### ADDENDUM #3

- A. Project Number: 2021-10628
- B. Project Title: Fueling Facility
- C. Project Location: 1229 W. Boone Avenue, Spokane, Washington
- D. Agency: Spokane Transit Authority

**2 VAULT LIGHTING ELEVATION**  
SCALE: 1/2" = 1'-0"

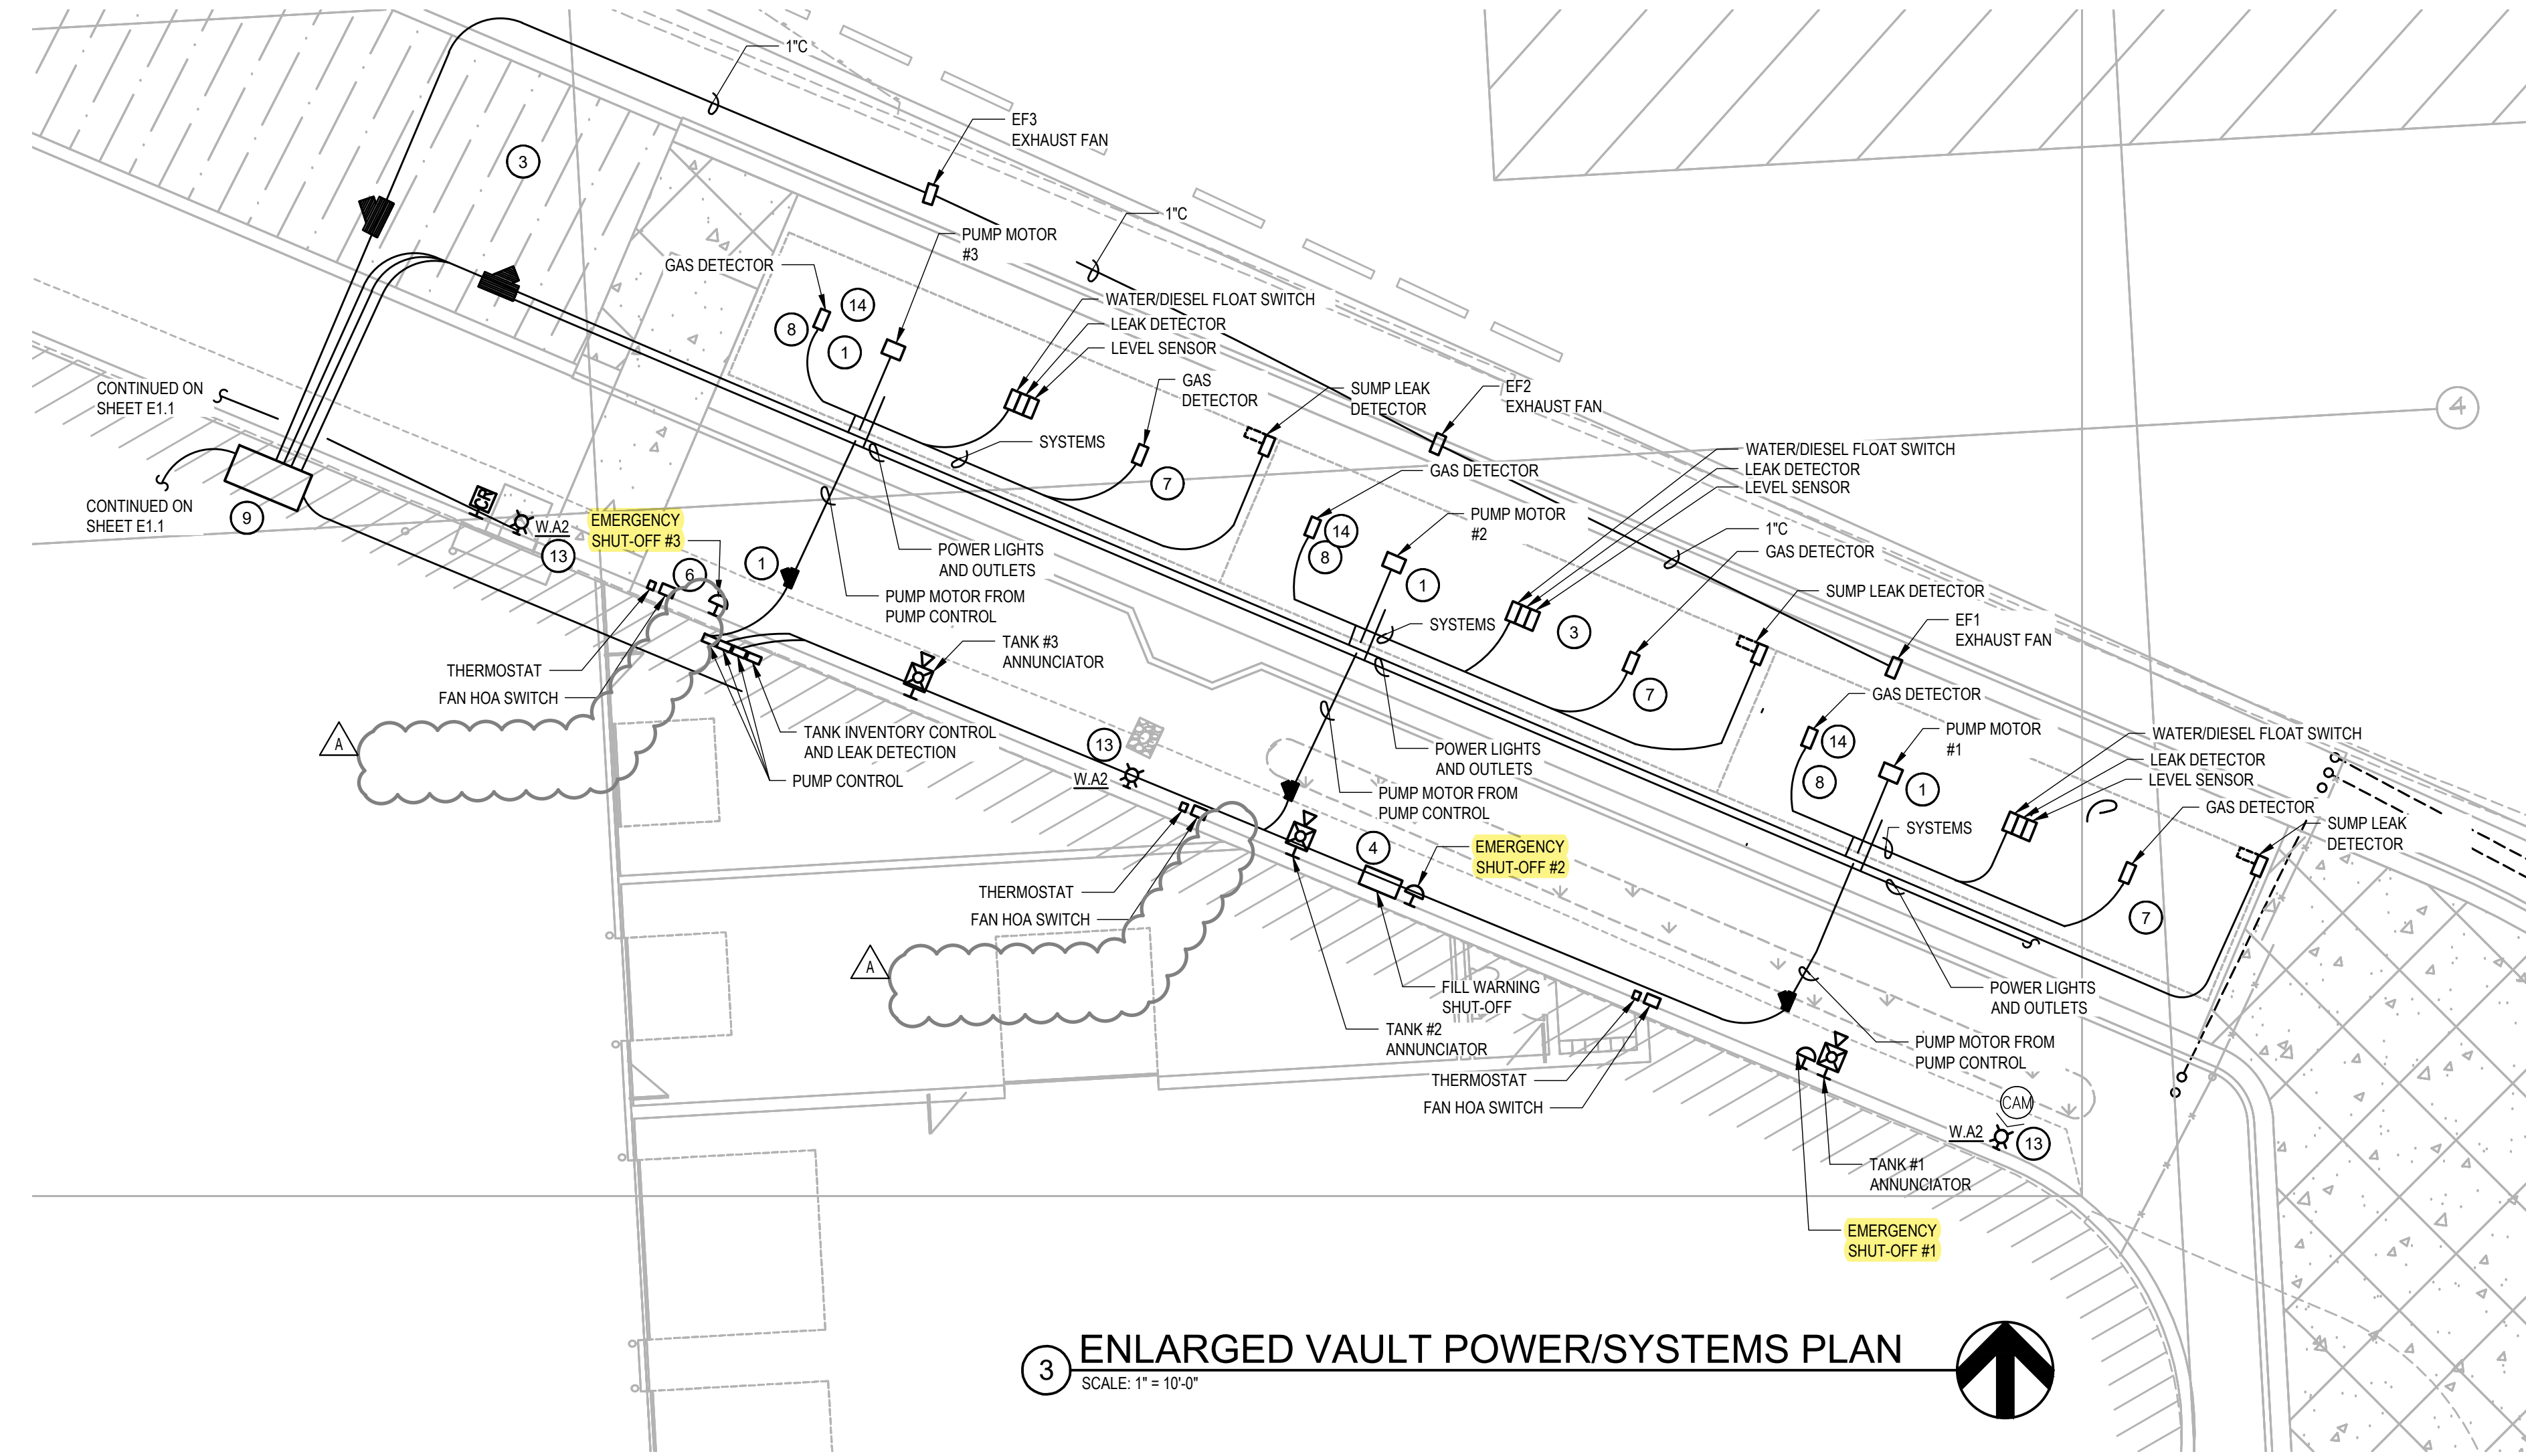
**Question 06:** *E4.1 - There are 2 ea Fire Dept Emergency Shutoffs shown, should there be 3?*

**Answer 06:** Three shutoffs are needed, one for each tank. The "Emergency Shut-Off" and the "Fire Department Emergency Shutoff" are actually the same, mistakenly shown as two different buttons. This has been corrected. Please see Section 1.4 above and the revision made to sheet E4.1, included with this addendum.
